### APPEAL SUMMARY

<b>Appeal ID:</b> 14925	<b>Project Address:</b> SW Park Ave & SW Columbia St
<b>Hearing Date:</b> 4/12/17	<b>Appellant Name:</b> Eric Buschert
<b>Case No.:</b> B-004	<b>Appellant Phone:</b> 503-224-9656
<b>Appeal Type:</b> Building	<b>Plans Examiner/Inspector:</b> Natalie Davis
<b>Project Type:</b> commercial	<b>Stories:</b> 7 <b>Occupancy:</b> R-2, S-2 <b>Construction Type:</b> I-A, III-A
<b>Building/Business Name:</b>	<b>Fire Sprinklers:</b> Yes - Entire building
<b>Appeal Involves:</b> Erection of a new structure	<b>LUR or Permit Application No.:</b>
<b>Plan Submitted Option:</b> mail [File 1]	<b>Proposed use:</b> Multi-family housing (apartments)

### APPEAL INFORMATION SHEET

(3) TOTAL GROUND-LEVEL LOFT UNITS WITH MEZZANINE,  
WITH ACCESS ONLY FROM SW PARK AVE.

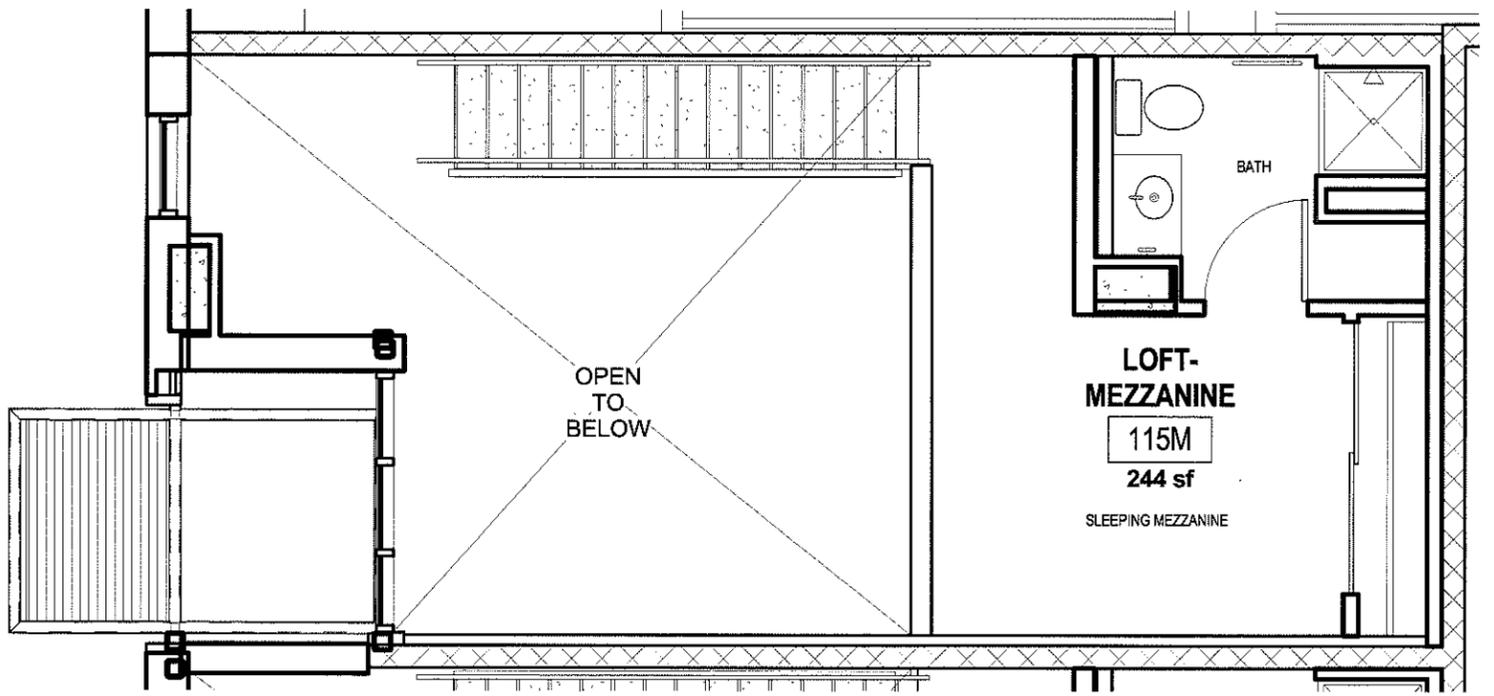
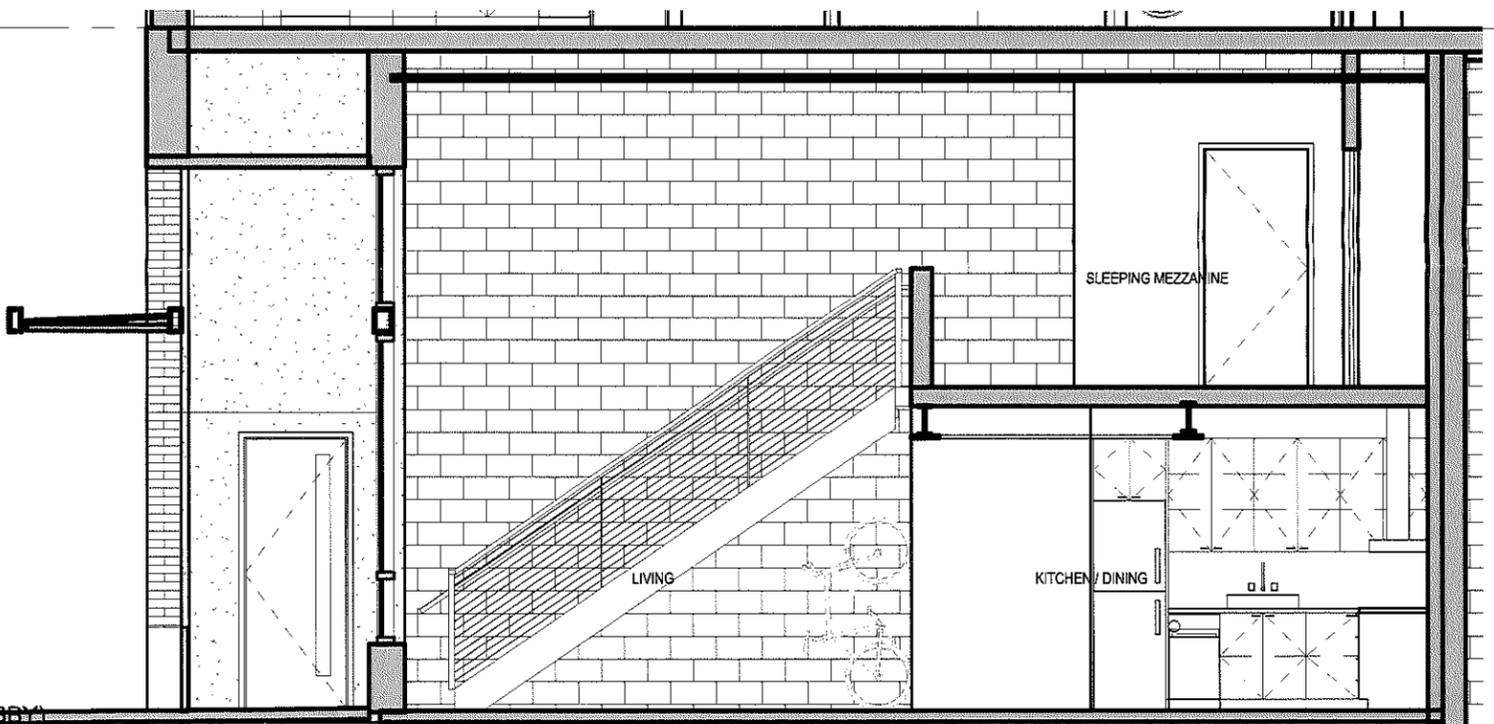
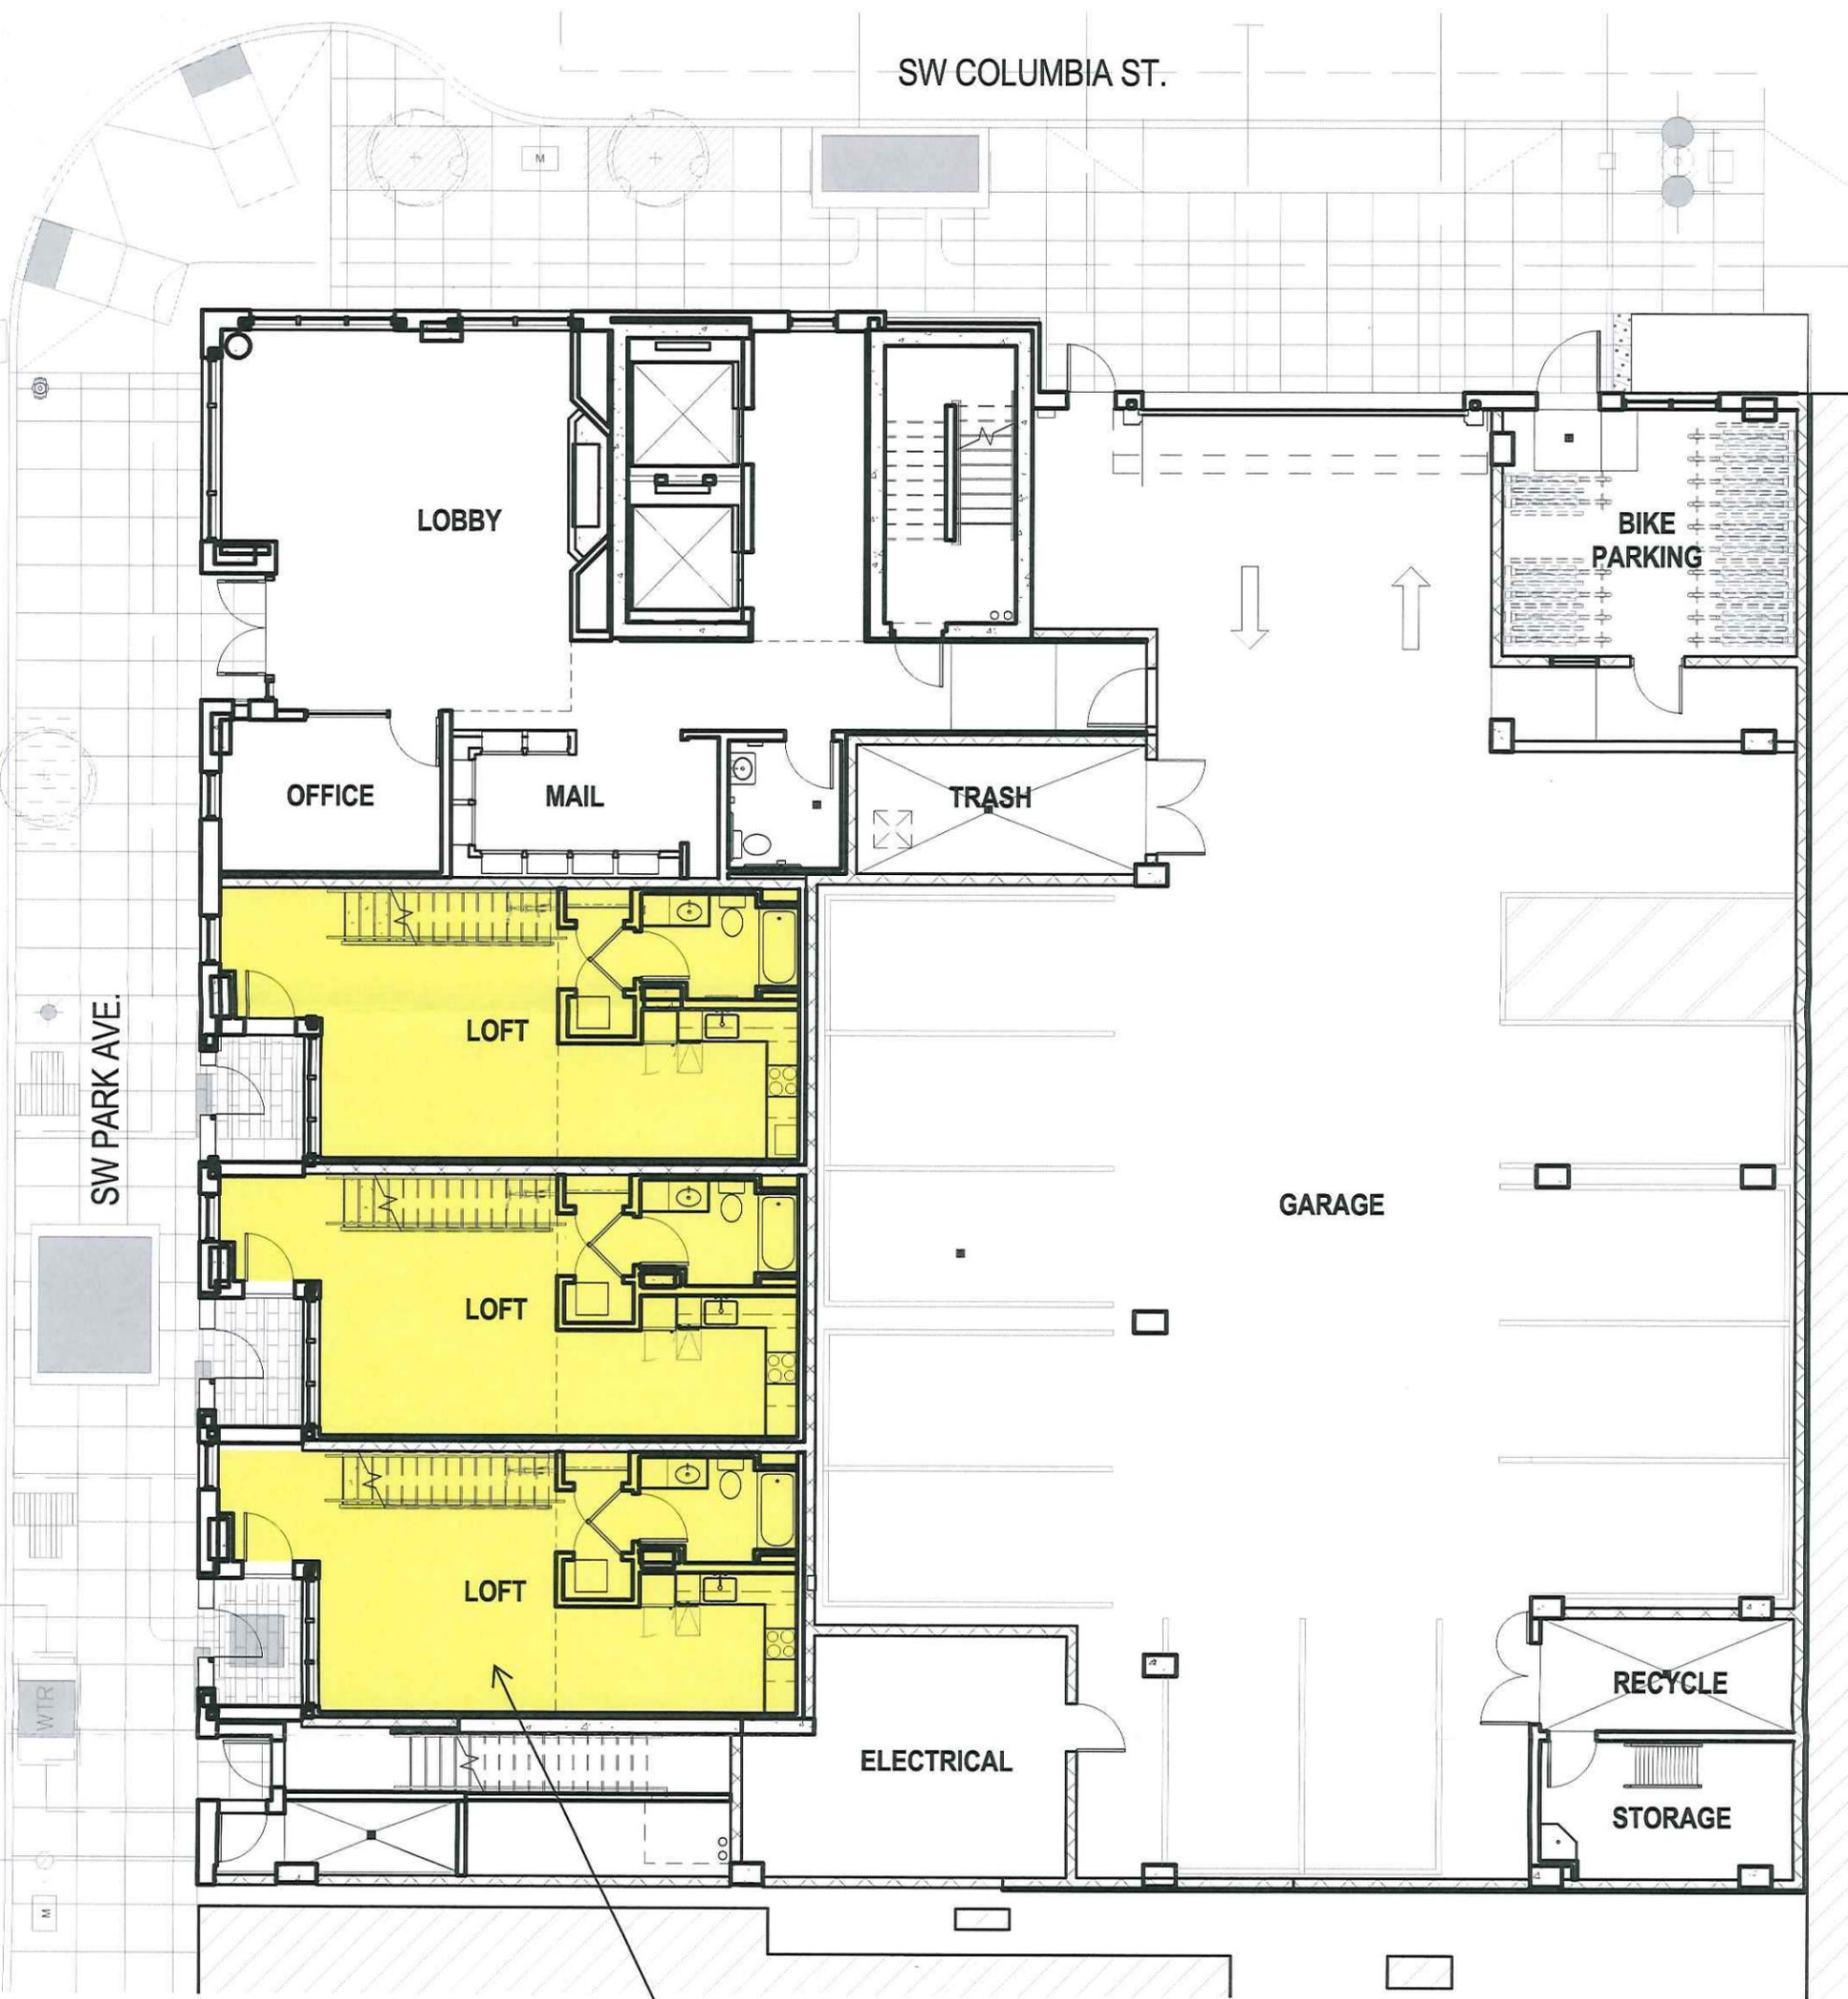
The project is designed as a 1/4 block "five-over-two" apartment building, with the lower two levels of Type IA construction and levels 3-7 of Type IIIA construction. The ground level plan includes the entry lobby, parking, bike storage, utility rooms and three residential units accessed only from the building exterior along SW Park Ave. Those three residential units each include a mezzanine or

"loft" level, accessed only by a stairway within each unit. Refer to attached unit floor plans and section.

Each mezzanine exceeds 1/3 of the area of the main level of the unit: the main level is 554 sf, and the loft is 224 sf (44% of the main level area). Considered another way, the overall ground floor of the building is 9,794 sf. The combined area of the three mezzanines is 672 sf, or 6.8% of the overall floor area. There are no other mezzanines in the building.

**Reason for alternative** The essence of this appeal is to allow a slightly larger mezzanine for three residential units. The size of the mezzanine is important in part for functionality, and in part relating to the size/proportion of the spaces that are aligned directly below it.

Although the mezzanine exceeds the 33% area maximum, the proposed larger area would only increase the occupant load in each unit by one. At 200 gsf per occupant, the main level of the residential units would have three occupants, and the mezzanine would add two more occupant, for a total of five per unit.

Egress from the mezzanine is very direct and clear, via an internal stair within each unit and directly to the exterior at the main level. The required door width for the exterior door would be 1". The maximum travel distance from the mezzanine is about 52 feet.

**2. Mezzanine floor area within (3) residential units exceeds 33% of the room it is within: Granted for this configuration and exiting without voice alarm.**
